Flight Procedures Cover Page	Task Action: FLIGHT CHECK	Task Type: IAP	Estimated Chart Date: 03/19/2026	APWS Task ID: 46E84FD1B0FC469E8C990E121F87A98F	APWS Project ID: 4565656BD4C94F4DAB88629B701AD00E
Procedure: RNAV (GPS) Y RWY 13R AMDT 1		Enroute: NO	Specialist: Young, Silvia		Agreement Number:
Airport ID: KDAL			Airport City: DALLAS		State: TX
Facility ID:	Facility Type:	Flight Inspection Remark Type: New FC Slot			
<p>Procedure Comments: ACTIVE DATA USED FOR KDAL AIRPORT AND RWYS.</p> <p>CANCEL NOTAM FDC 5/3067.</p> <p>APPROVAL LETTER: 1. MANDATORY ALTITUDE AT WENOP.</p> <p>CONTACT CASIMIR TABAKA 405.202.7857</p>

# RNAV (GPS) Y RWY 13R

DALLAS LOVE FLD (DAL)

Subject: Letter of Approval Request KDAL RNAV (GPS) RWY 13R

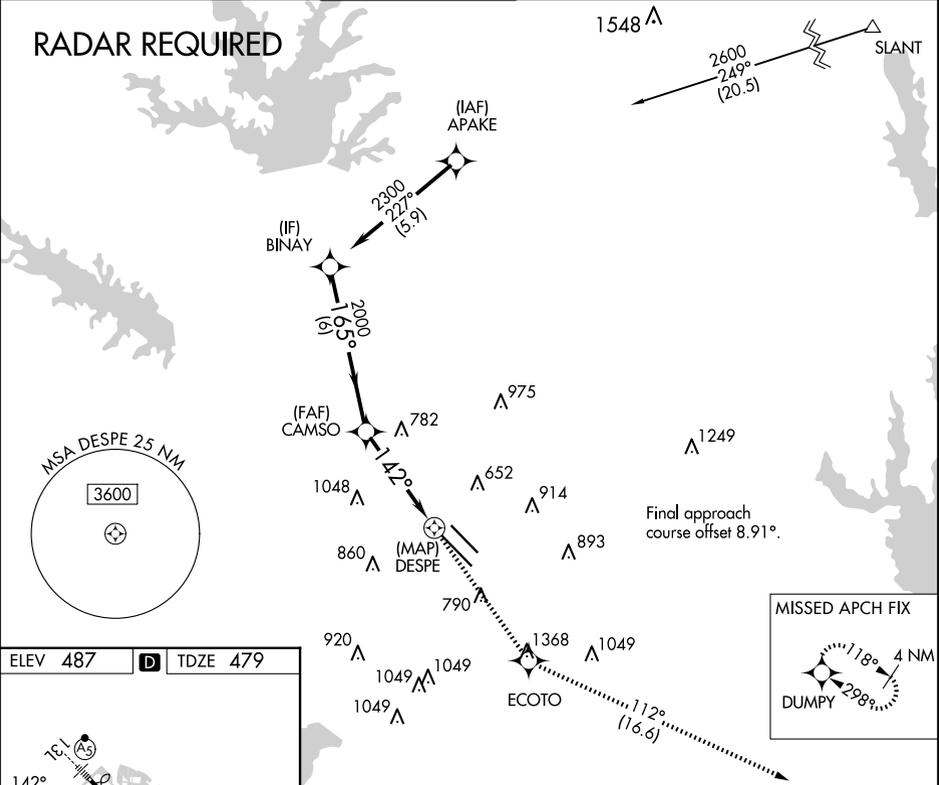
KDAL RNAV GPS RWY 13R: WENOP Mandatory Altitude.

Lonestar (D10) TRACON requests AFS approval to chart a mandatory altitude restriction at the following fix: WENOP at 3000ft MSL for RNAV GPS RWY 13R instrument approach procedure for Dallas-Love Field (KDAL).

Currently, FAAO 8260.19K paragraph 8-6-11n (1) requires Flight Standards approval from the Flight Technologies and Procedures Division to chart a mandatory altitude on the intermediate segment of an instrument approach procedure.

Therefore, Lonestar TRACON requests to chart the mandatory restriction at WENOP RNAV GPS RWY 13R. This is an ATC operational request to ensure vertical separation between aircraft on the approach and other traffic.
